BID CLARIFICATION NO. 2

TO: All Subcontractors / Suppliers
FROM: Dan Korcek, Senior Project Manager; Morgan Gross, Assistant Project Manager
DATE: October 20, 2026
RE: **NVPS Athletics Addition and Renovation**

Project: NVPS - Northview Athletics Stadium
Addition & Renovation
4451 Hunsberger
Grand Rapids, Michigan 49525
P: 616-327-9354

2924188 A

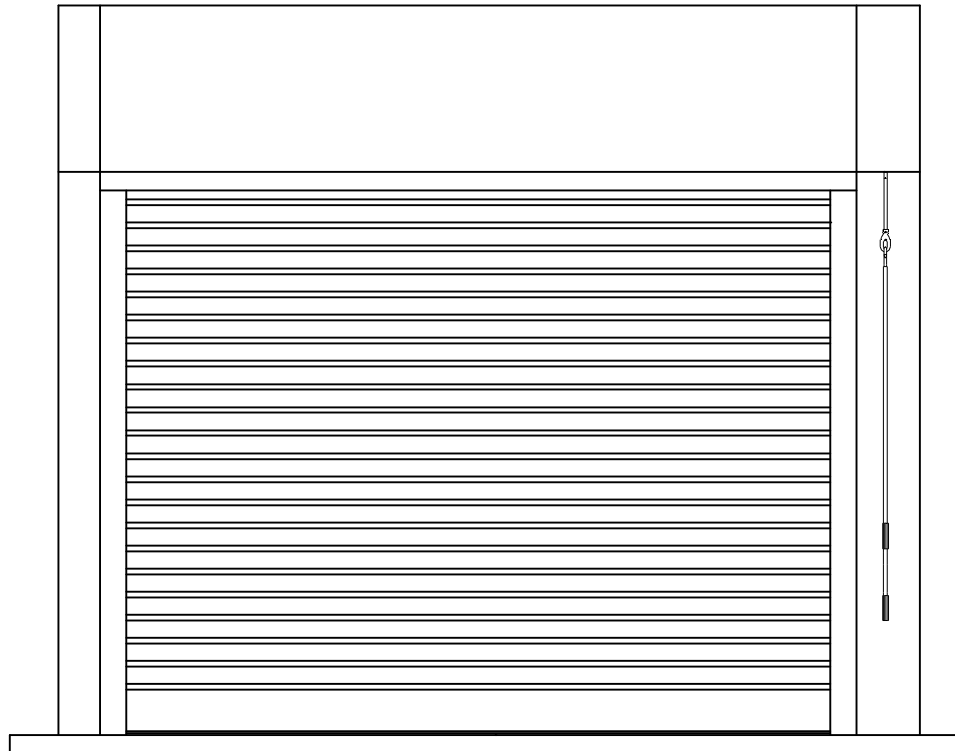
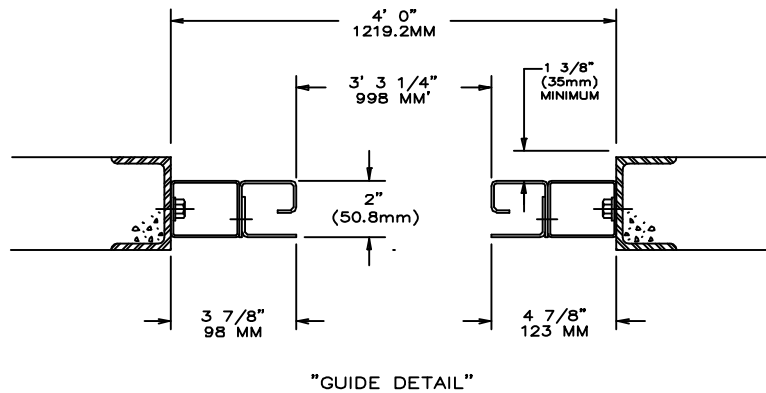
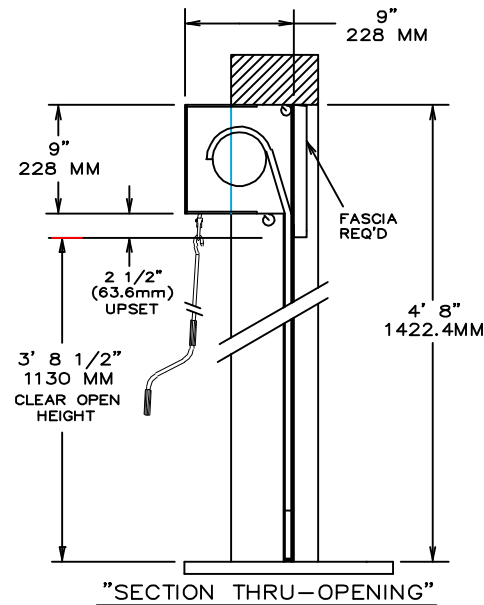
Interested bidder in the General Trades/Door Category is interested in an alternative door being approved via substitution request. Please see the attached information and provide a response if this is acceptable as a substitute or not.

Substitution request would allow the opportunity to source both coiling and sectional doors from a single source.

Proposed Manufacturer: Raynor Proposed Item / Model: Durashutter

Differences between proposed Substitution and specified item: Raynor product appears to meet specifications.

Provide explanation of Benefit: Single source both sectional and coiling doors from same manufacturer. Raynor is listed as a supplier for the sectional doors

The presented Raynor Overhead Door substitution is acceptable.
